SUNNICA ENERGY FARM

EN010106

8.82 FRA clarification document in light of proposed Scheme changes

Version	Date	Status of Version
Rev 00	13 January 2023	Submitted at Deadline 5

Drawing Title
**FIGURE 3-1
 SUNNICA EAST
 PARAMETER PLAN**

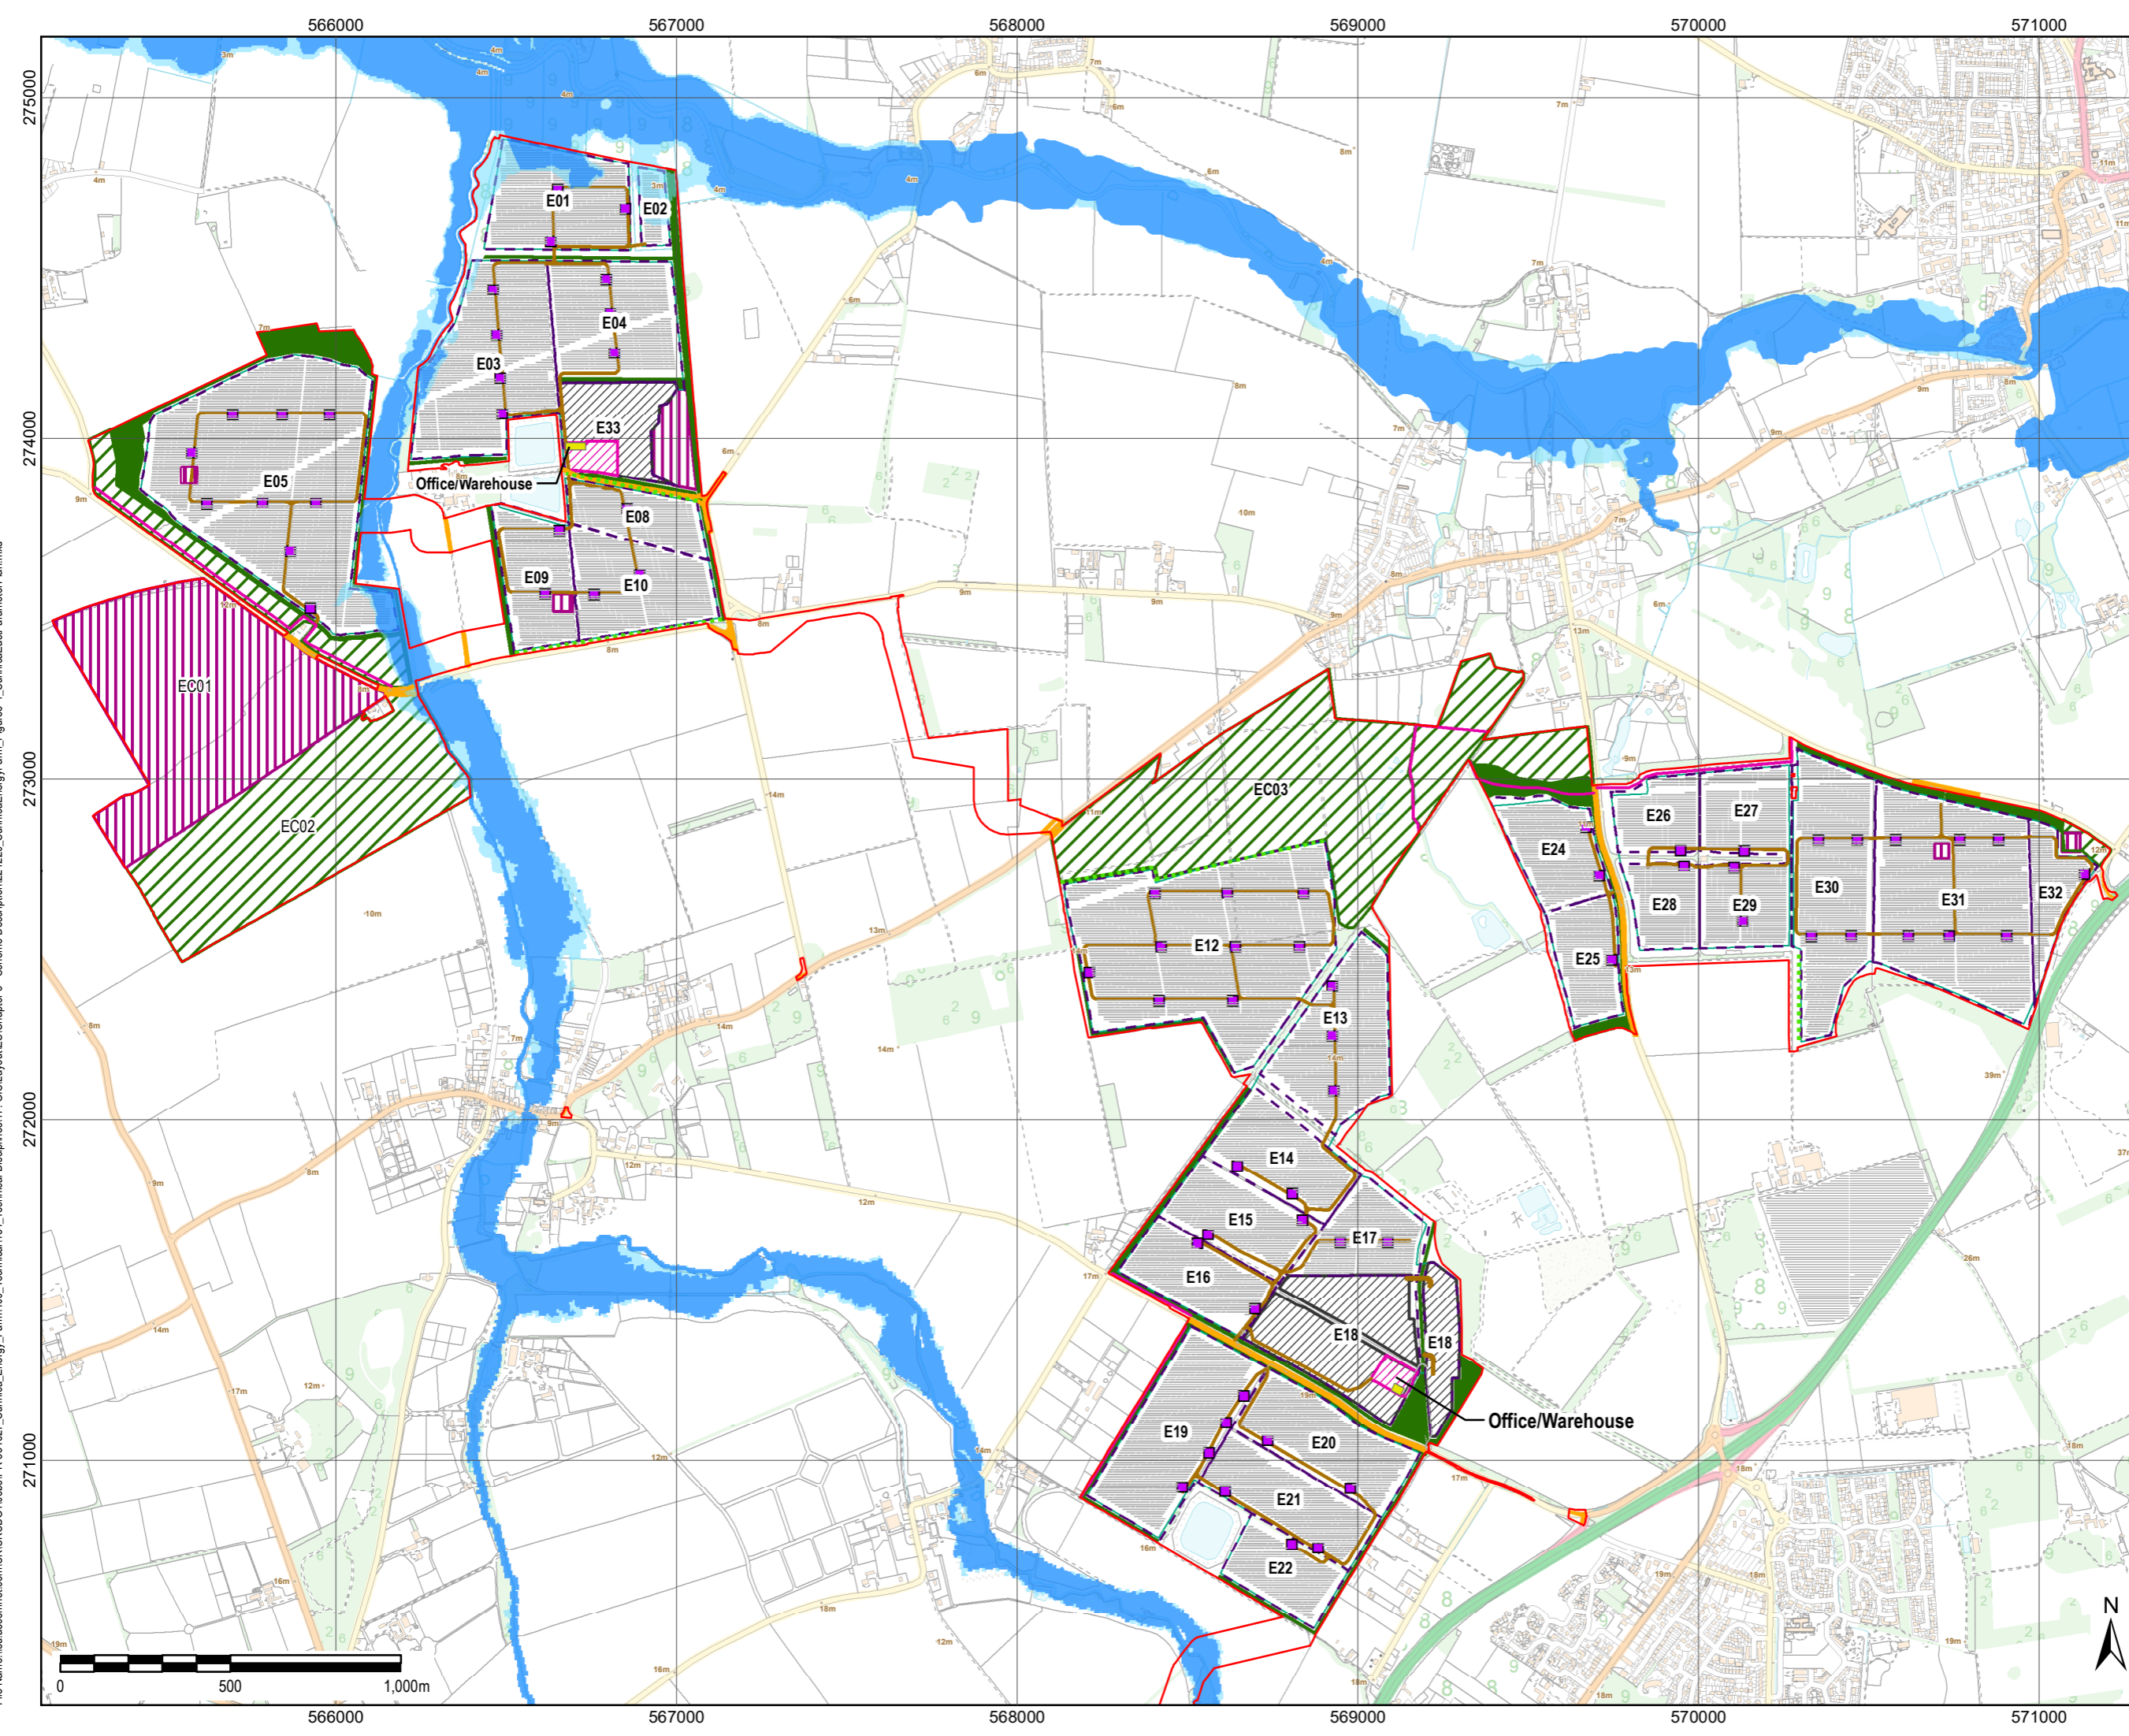
Note: Developable fields previously referred to as E06, E07, E11 and E23 are no longer being developed with solar infrastructure and now form part of the mitigation strategy; however, the field numbering for the remaining developable fields has been retained for consistency.

Drawing Title
**FIGURE 3-2
SUNNICA WEST
PARAMETER PLAN**

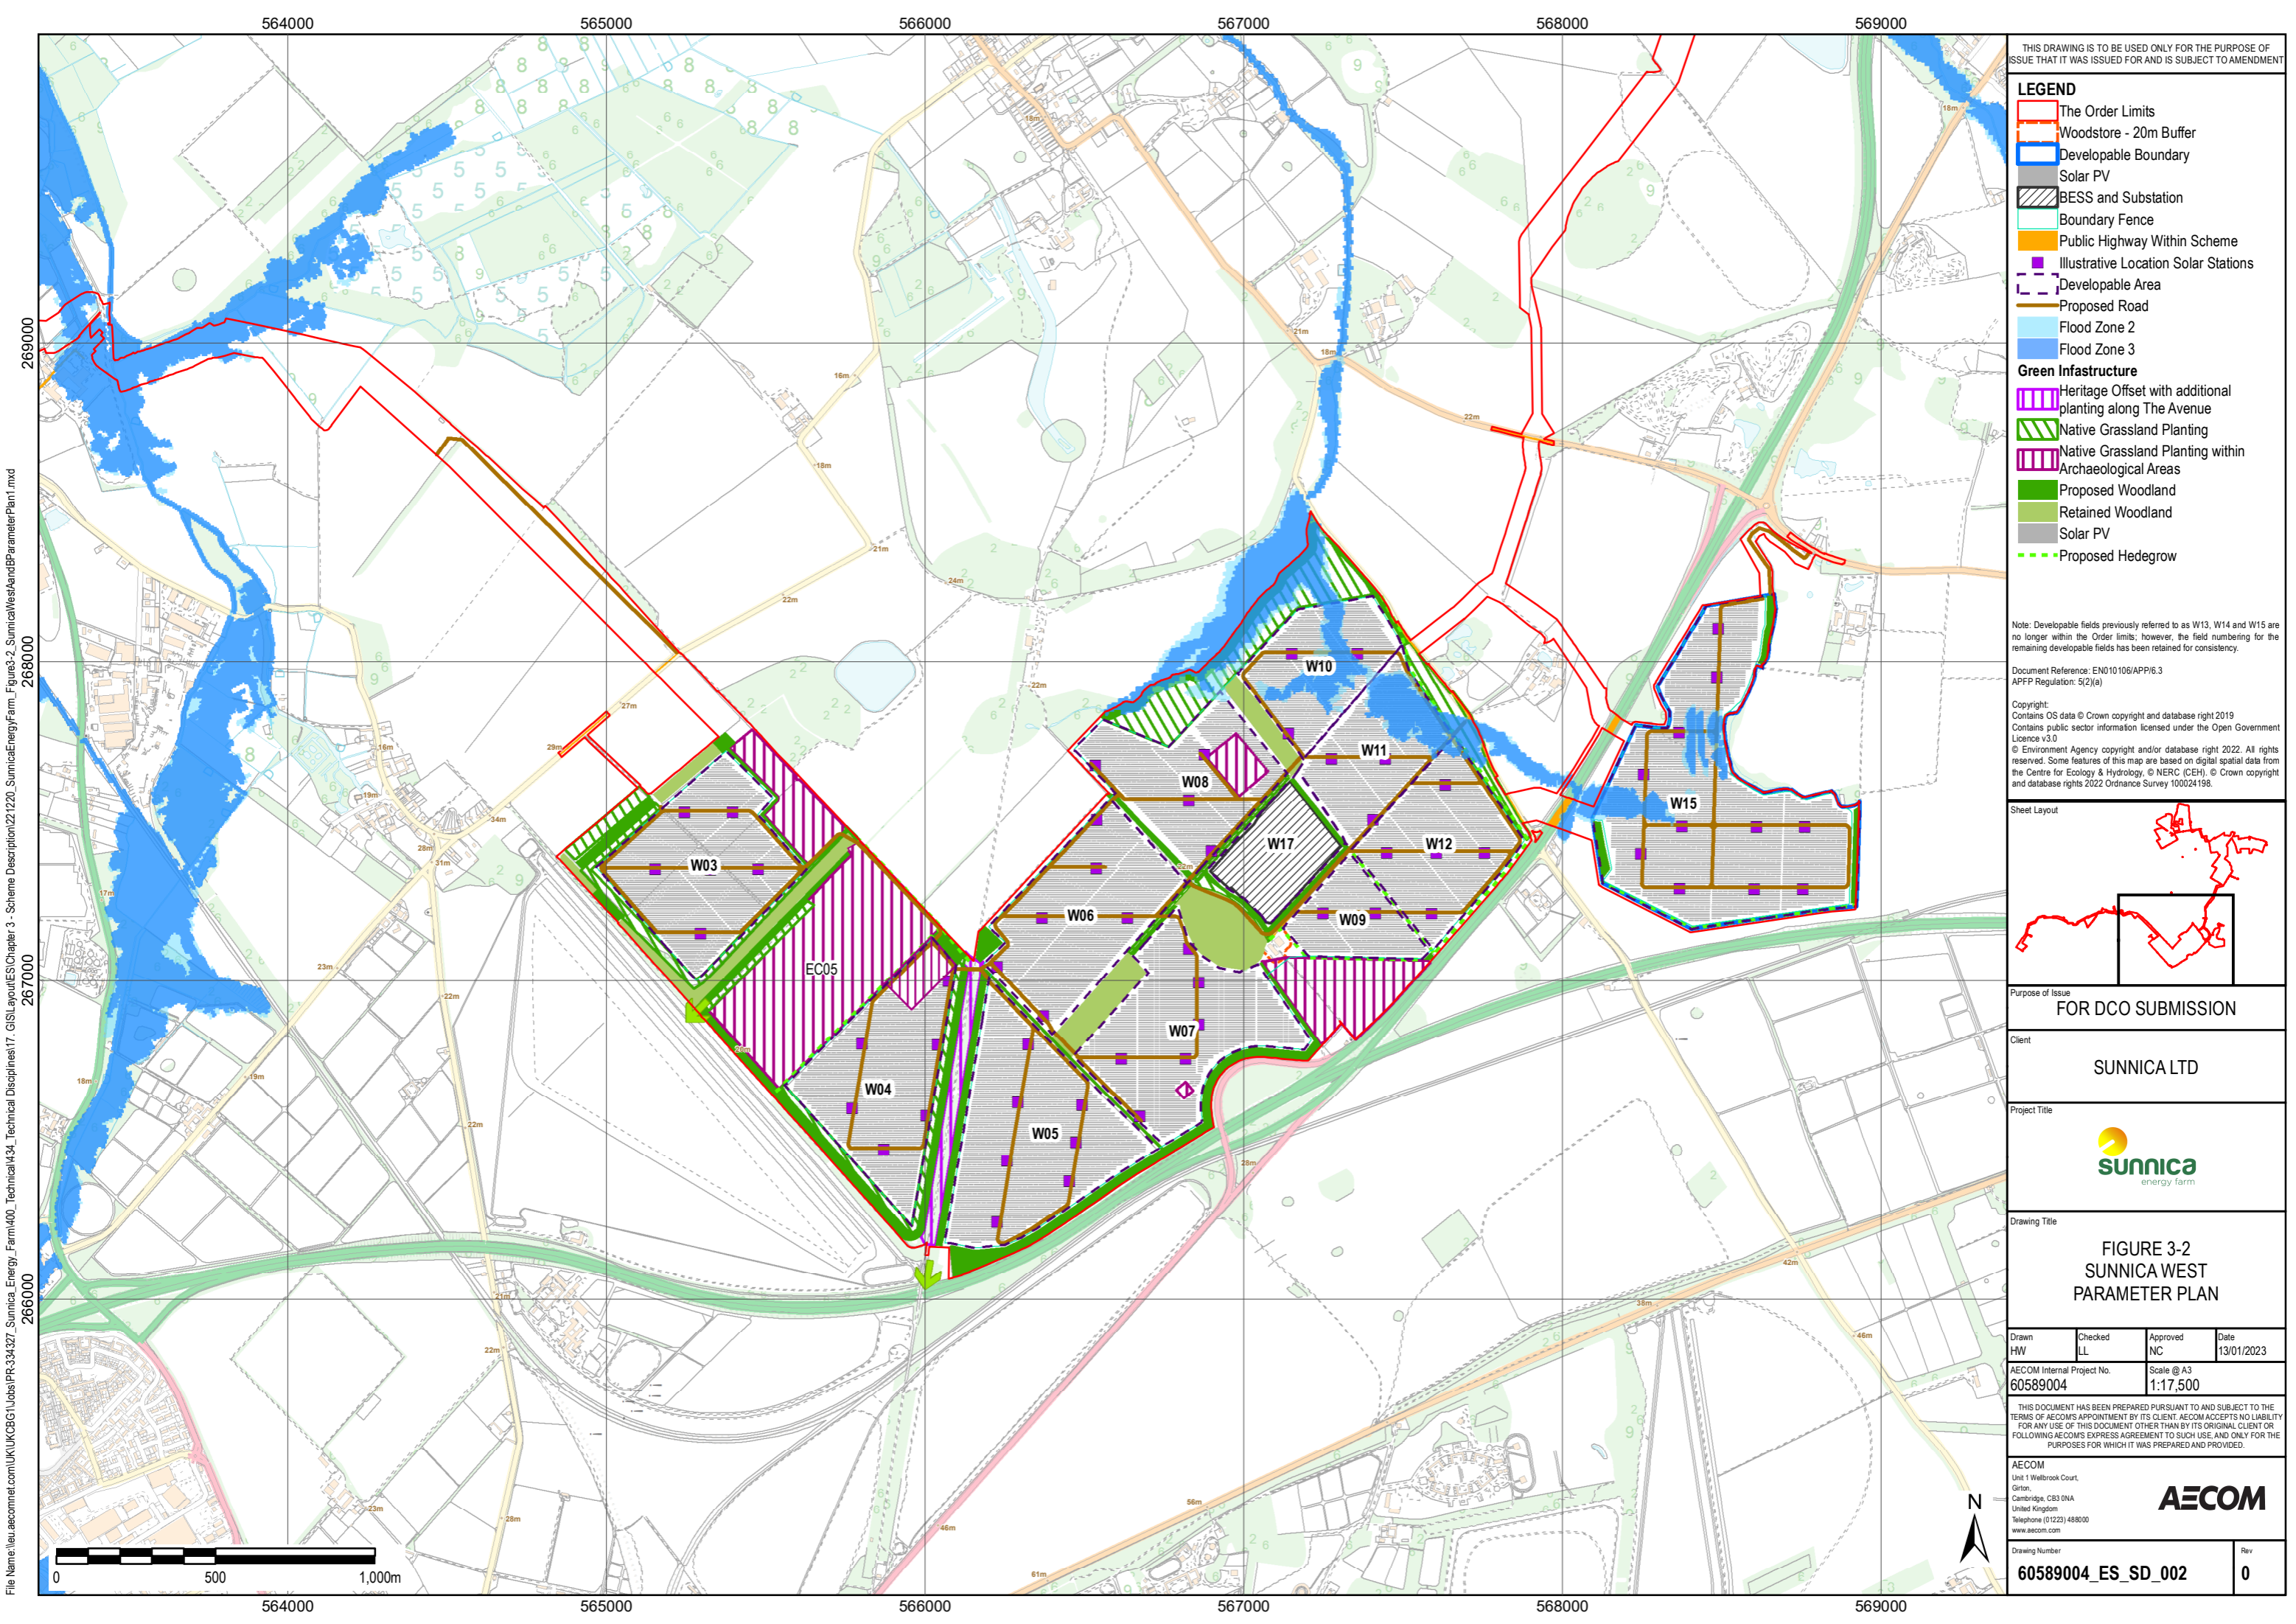
Note: Developable fields previously referred to as W13, W14 and W15 are no longer within the Order limits, however, the field numbering for the remaining developable fields has been retained for consistency.
